Ridgeway Arizona Oil Corp (Ridgeway) requests approval to plug and abandon the Farrell Federal #17 according to the attached proposed plugging procedure and well bore diagram.

Plugging Procedure Farrell Federal #17 API - 30-041-20693 Sec. 28, T7S, R33E, UL-A 1310' FNL 1310' FEL

Farrell Federal 17 30-041-20693 Ridgeway Arizona Oil Corp November 21, 2017 Conditions of Approval

)	
Co. Rep	0	
Well Name	Farrell Federal	Well No. 17
Field	Chaveroo San Andres	
County	Roosevelt	-
State	NM	_
Date		_
Date Comp		_
KB	4406.8 KB

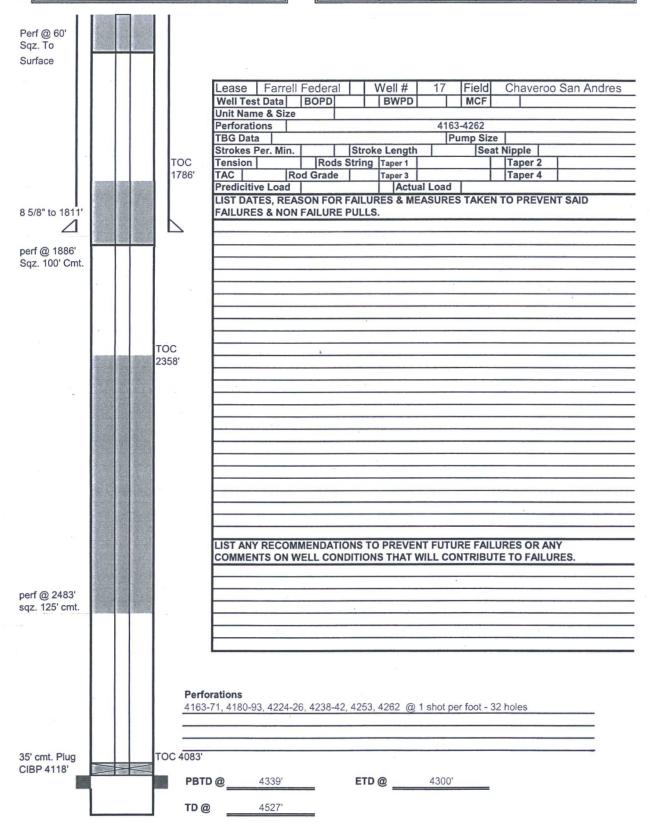
8. TIH w/WS Squeeze 125' cement @ 2483' to 2358' (+/-) must sent top of yellar!

must have 50 above and 50 be low casing shae!

- 1. Operator shall place CIBP at 4,113' (50'-100' above top most perf) and place 35' of Class C cement on top as proposed. WOC and TAG.
- 2. Operator shall perf and squeeze at 2,483'. Operator shall place a balanced Class C cement plug from 2,483'-2,200' to seal the top of the Yates formation. WOC and TAG.
- 3. Operator shall perf and squeeze at 1,886' as proposed tagging plug at 1,761' to seal the surface shoe.
- 4. Operator shall place a balanced Class C cement plug from 60'- surface as proposed
- 5. See Attached for general plugging stipulations.
